# 3505 South Bennett Street

MUP Recommendation Packet | Project #3029506 | January 29, 2019

**b9** architects

① View looking Southeast at Corner Facades

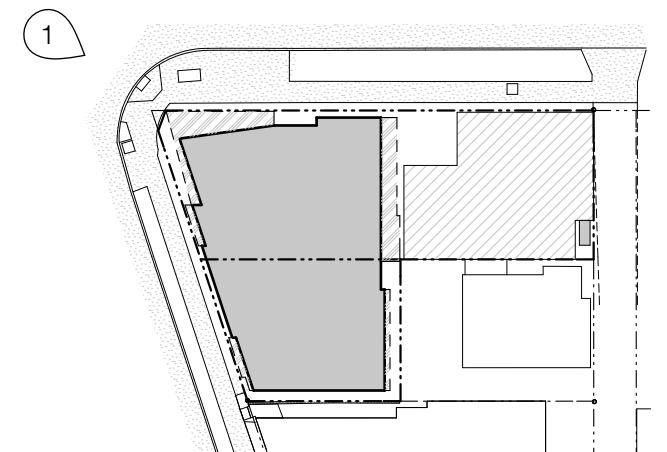
**b. The Board supported the proposed articulation of the preferred massing option, and noted that the framing elements and modulation contribute to a grounded feel that is typical of traditional rowhouses. The Board strongly encouraged further development of this residential expression.**

**c. The Board specifically prioritized Design Guideline DC2-D-1, Human Scale, and encouraged the incorporation of secondary architectural features and massing moves that establish a human scale and contribute to a strong residential expression. These features should ultimately be informed by the design of the amenity area and “front porch” concept.**

- The design of the proposed articulation of the preferred massing option has evolved in response to the Board's guidance.
- Specifically the design of the overall massing and highlighted façade framing elements create a consistent compositional gesture throughout the project.

- The linear framing elements introduce a residential scale to the facade, evoking a traditional rowhouse form.
- Alternating parapets and roof overhangs, combined with window patterning and alternating exterior siding materials further articulate the preferred alternative.

- Secondary architectural features have been incorporated to add to the residential character and human scale of the project. They include an entry canopy, roof projections, horizontal and vertical framing elements and metal railings.

- These elements all help define the residential entry and associated “front porch” amenity area.
- It creates a space for the residents that contributes to the streetscape at the corner of Martin Luther King Jr Way South and South Bennett Street.

- The front porch connects the streetscape to an interior amenity area through a terraced planter, metal railing and wood deck.
- The covered front porch is further defined by a wood soffit above and contrasting siding material creating an inviting space for residents and guests. It has been increased in size to make it more successful and to allow for gathering and seating.

1 View looking West at Rear Facade

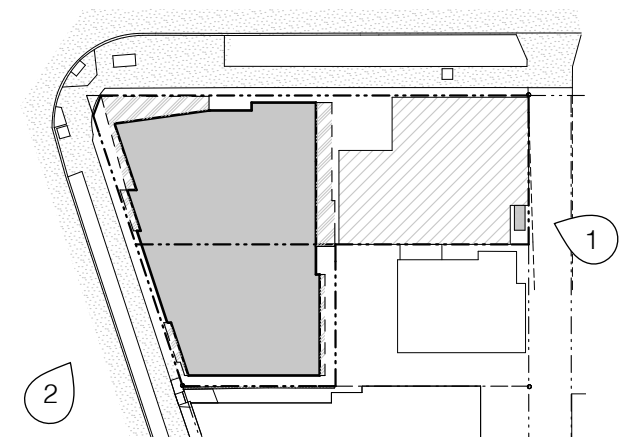
**d. The Board supported the double height units, and stated the exterior façade composition should reflect that internal configuration.**

- The proposal evolved since the Early Design Guidance meeting, taking advantage of a change in the Land Use Code to allow for a parking reduction due to the site's proximity to the LINK Light Rail Station at S Dawson Street.
- As a result the double height units have been replaced with another floor of units, increasing the number of family sized units while maintaining the overall building massing and design concept.
- The design proposal is still the same height. The exterior façade composition has developed consistent with this approach.

1 Ground Level Axonometric View

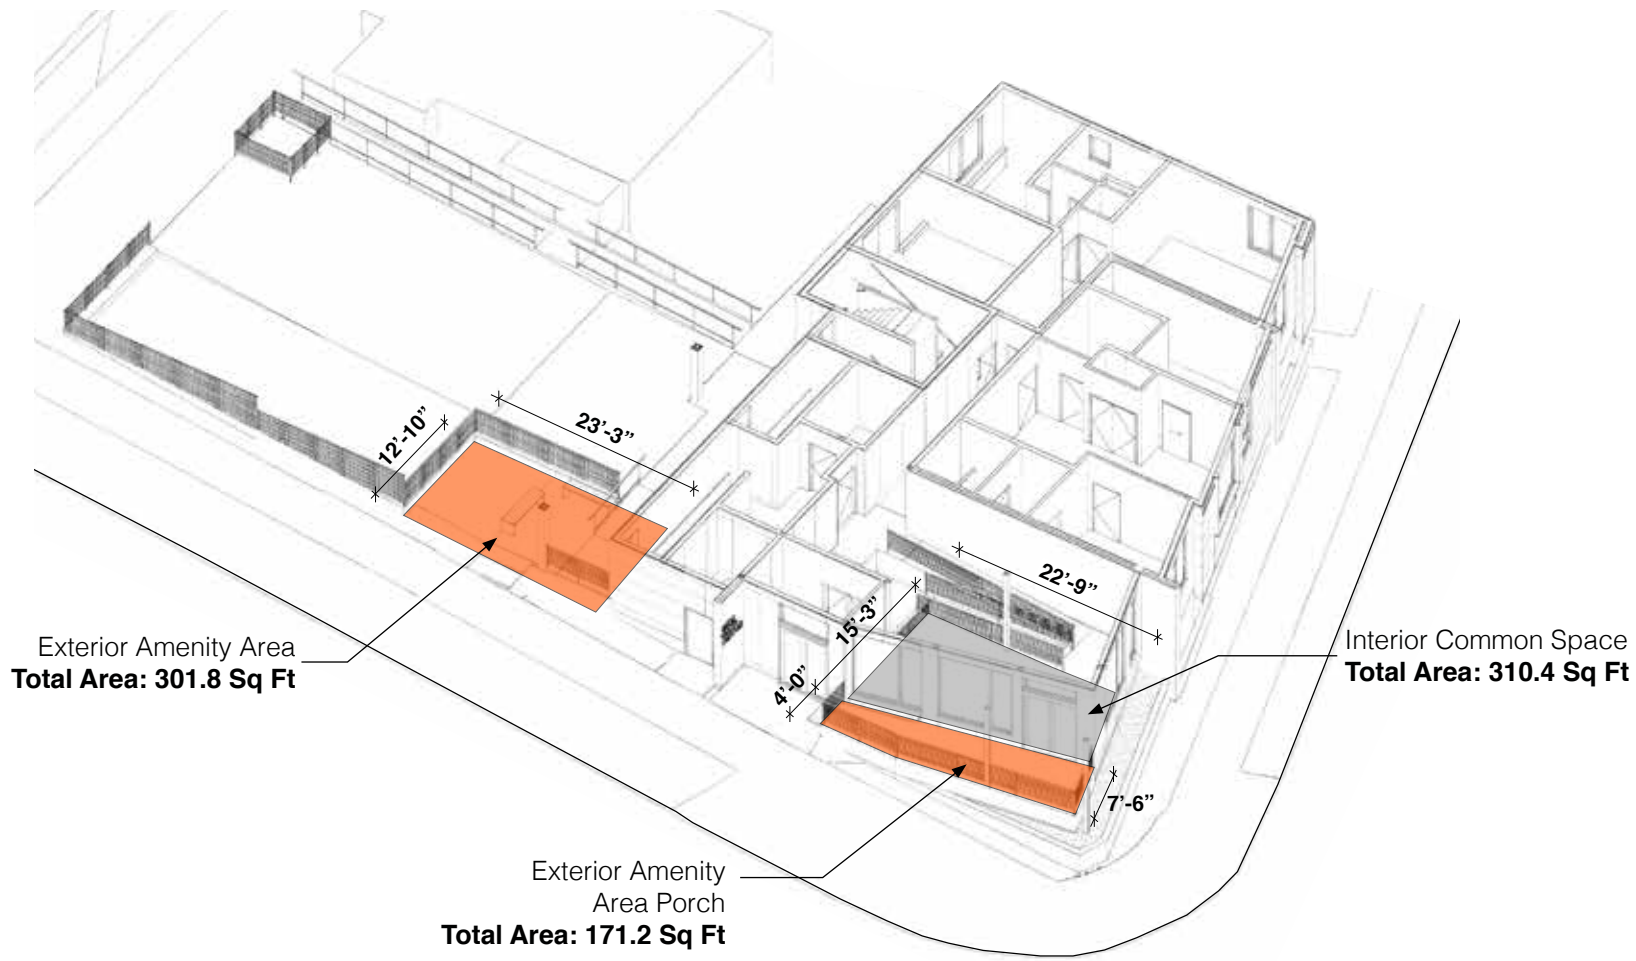
**a. The Board generally supported the concept of an internalized amenity area as an active street use, however, they questioned whether it would be successful. The Board was concerned that the internalized amenity space could go unused, based on observations of similarly designed spaces, and noted that the appeal of an external amenity space is that it provides something that is not available in each individual residential unit.**

- In response to the Board's concern, the amenity area has been improved to ensure it will be more successful.
- The building design evolved to create an exterior covered "front porch" that connects to the interior amenity space. This encourages activity by providing an extension to the indoor space.

- This provides an interior and exterior relationship that compliments the experience in the individual units.
- The "front porch" amenity area is accessible from the interior amenity area which is accessible from the main lobby.

- Seating and landscape planters are provided at the front porch to further encourage residents to use the space and provide a buffer to the adjacent sidewalk and street. It is further defined by a terraced landscape area along the sidewalk that visually connects the front porch to the sidewalk and planting strip.

- In addition, a secondary exterior amenity area has been provided to the east of the structure along S Bennett Street at grade to support a variety of options for residents.

A S Bennett St Detailed Section

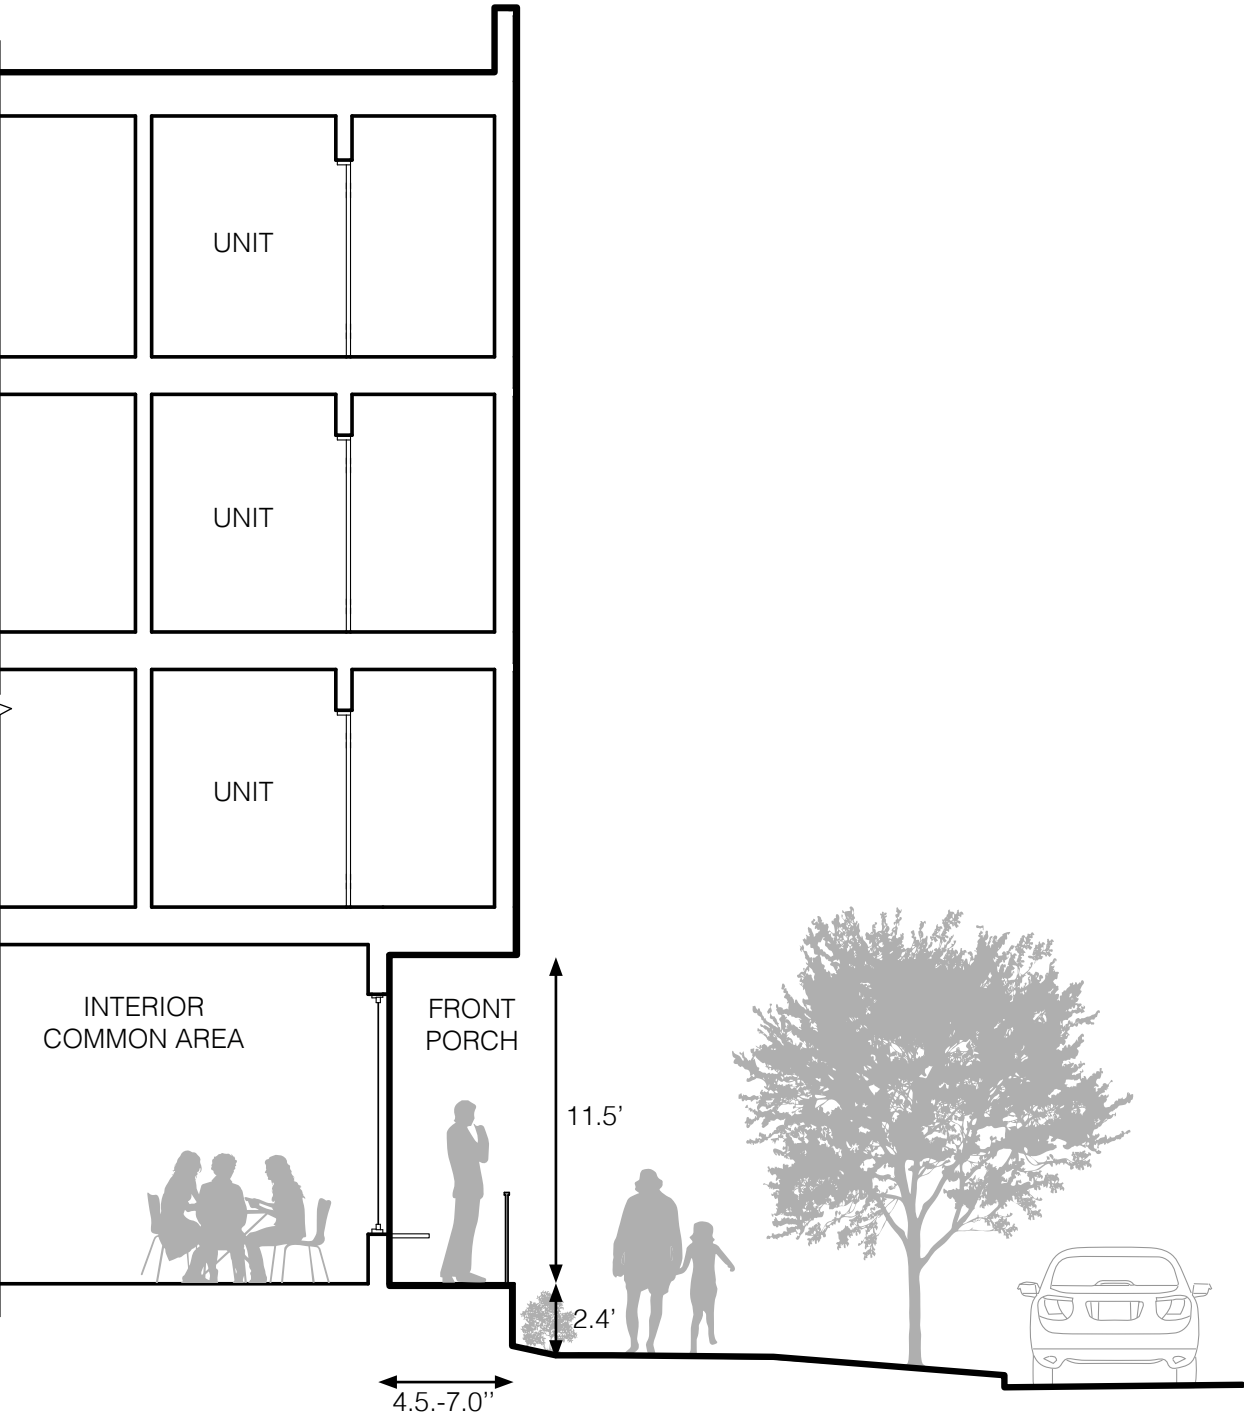
**b. The Board prioritized further development of the internalized amenity area in a manner that creates a strong connection to the street, contributes to the residential expression, and adds value. The Board encouraged a layered approach that softens the boundary between the interior amenity area and public realm, allowing the amenity area to open up and spill out into a semi-private space – creating a “front porch”. The Board noted this expression could also be achieved by allowing the adjacent lobby space and residential unit to occupy the setback and activate the exterior space adjacent to the internalized amenity area.**

- The design evolved to create a layered approach between the sidewalk and the interior amenity area. Refer to response to “a” above.
- The area’s edges are softened by the terraced planters along it’s base at the sidewalk, improving the boundary between private and public, creating a semi-private space for residents to take advantage of.
- The amenity area design has evolved, refer to responses to “a” and “b” above. In additiion, please refer to amenity area alternative studies on pages 28-29.

(B) Martin Luther King Jr Way S Detailed Section

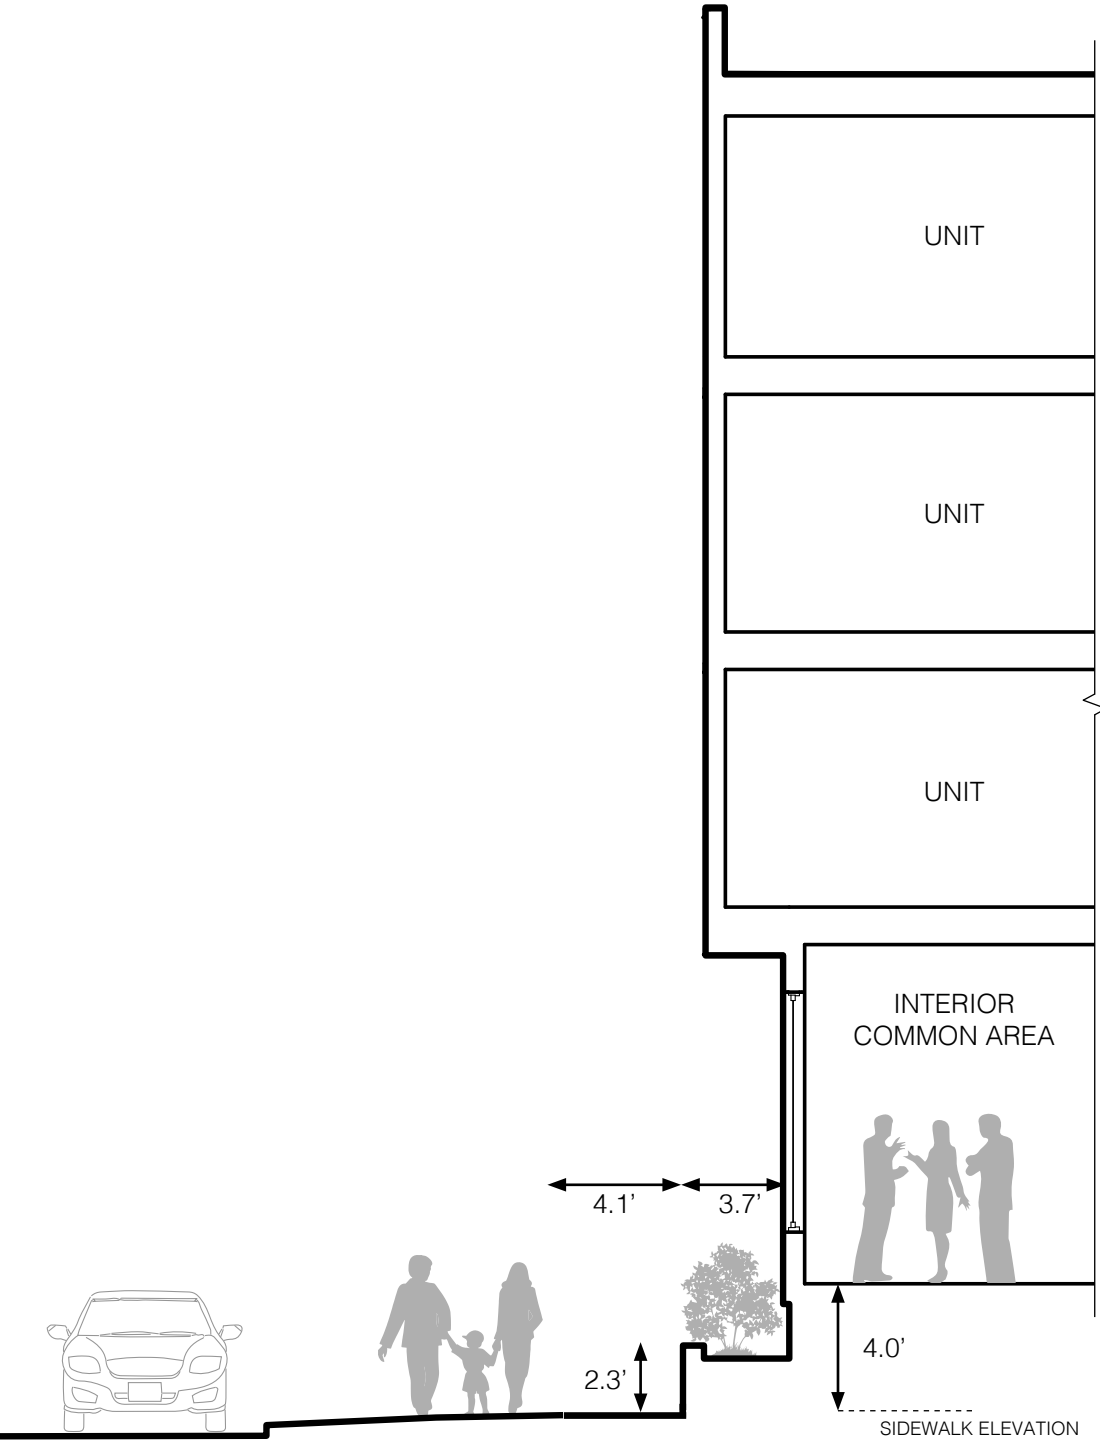
**d. The Board supported the proposed location of the primary entry off S Bennett St, however, they noted that the treatment of the 4-foot blank wall along MLK Jr Way S requires further study. The Board indicated they would be open to a departure from the required 4-foot vertical separation between ground-level residential uses and the sidewalk, provided that the departure helps facilitate the resolution of the guidance discussed herein.**

- The proposed development has maintained an entry off of South Bennett Street. This entry is articulated through a recessed wall of a contrasting material, an entry canopy, the “front porch” described above and a set of terraced planters.

- The 4-foot vertical separation between the ground-level residential use and the sidewalk along Martin Luther King Jr Way South is required due to the project utilizing the additional height permitted under SMC 23.47A.012.A.1.a. This 4-foot separation is not departable, per SDCI. The additional height permits the project to increase its total height to four stories from three stories with a mezzanine, and in turn, provides more family sized housing units, a goal of the city of Seattle and our client.

- The 4-foot vertical separation between the ground-level residential use and the sidewalk along Martin Luther King Jr Way South has been designed to maintain privacy for the residential uses while providing a landscape buffer between the sidewalk and the building facade. The design includes framing elements, materials, projections to break up the continuous wall along the street.

C Amenity Area Detailed Section

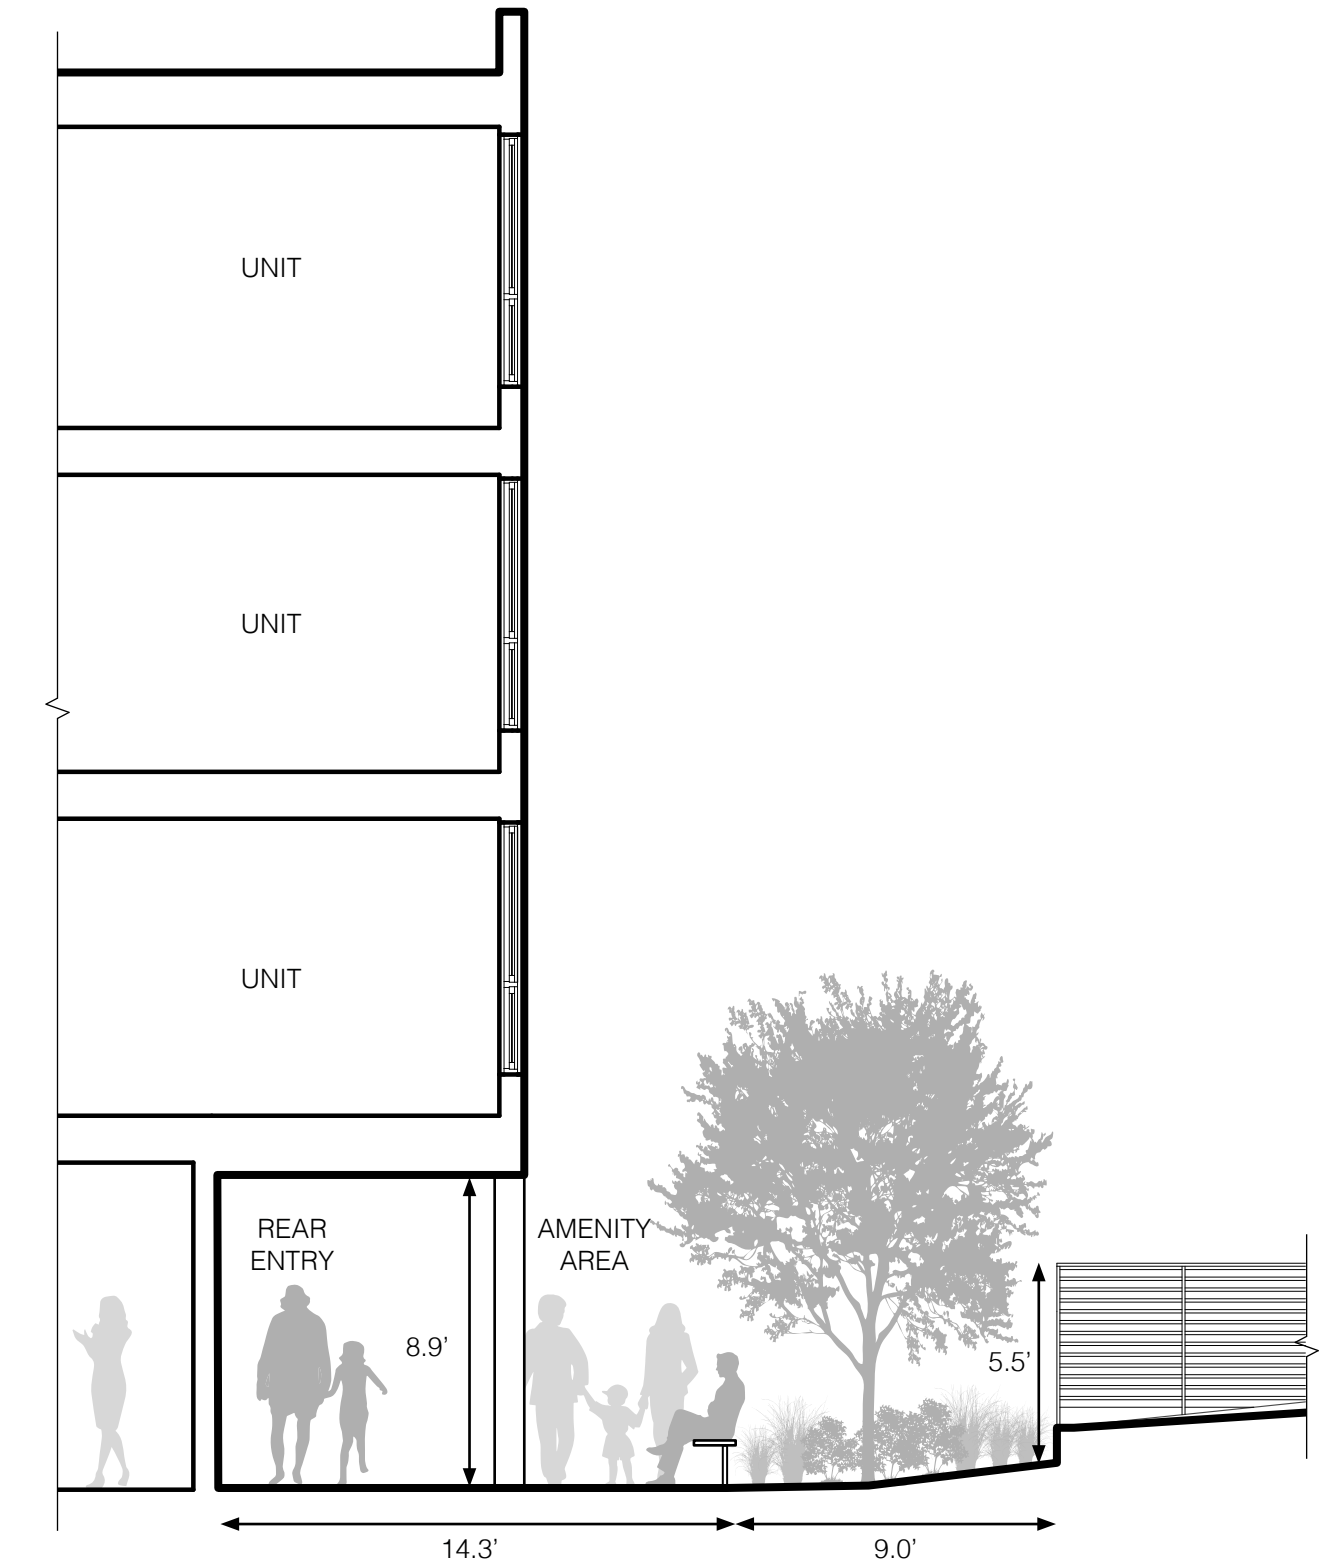
**e. The treatment of the ground-level façade along MLK Jr Way S should enhance the connection to the street, take cues from the design of the amenity area and “front porch” concept, and establish an architectural language that wraps the corner onto S Bennett St.**

- The “front porch” wraps the corner from S Bennett Street onto Martin Luther King Jr Way S, buffered by terraced planters that all create an singular expression of the predominant corner.
- The street-facing facades feature framing elements as described above in response to Item “1” that ground the facade at the street and articulate rhythm in the proposed massing.
